LINCOLN COUNTY
DEPARTMENT OF ENVIRONMENTAL HEALTH
WASTEWATER TREATMENT AND DISPOSAL SYSTEM PERMIT

LOT LAYOUT

PARCEL B-3 RE-WRITE
PARCEL B-3 PER C.O.S. 4552
IN THE NE1/4 OF SECTION 24
TWP. 31 N., R. 34 W., P.M.M.
For: Linda J. James
Jack B. Templin
Ida M. Templin
Date: October 2019

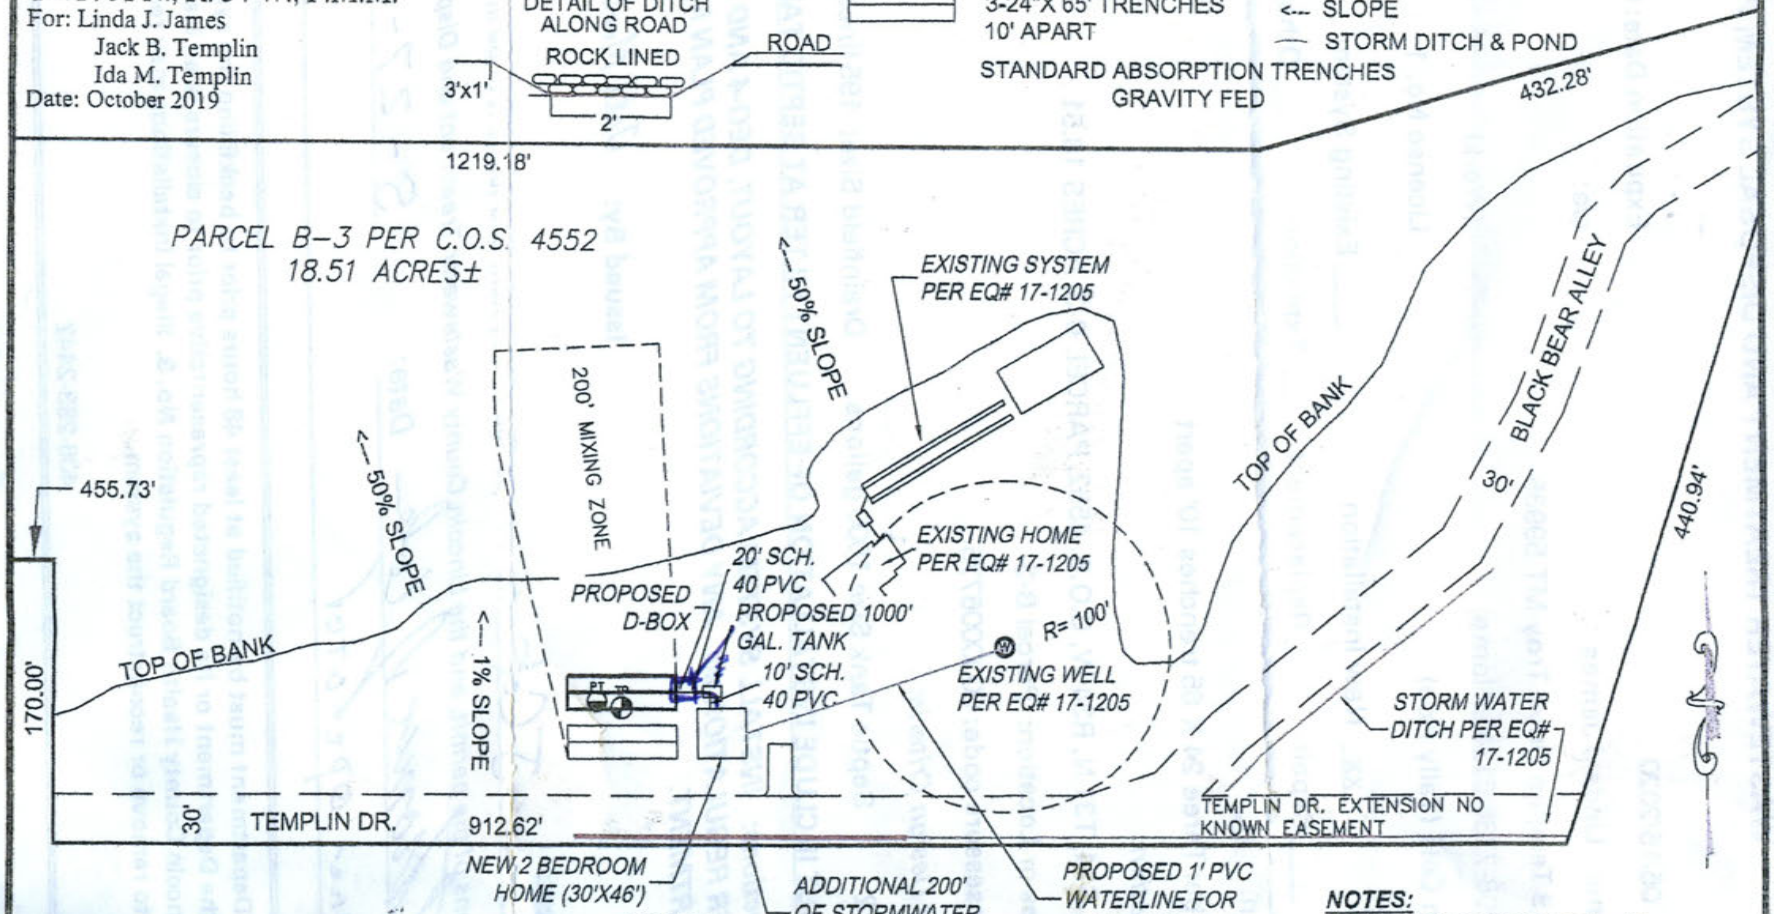
tank moved out to front of house
drainfield moves out further
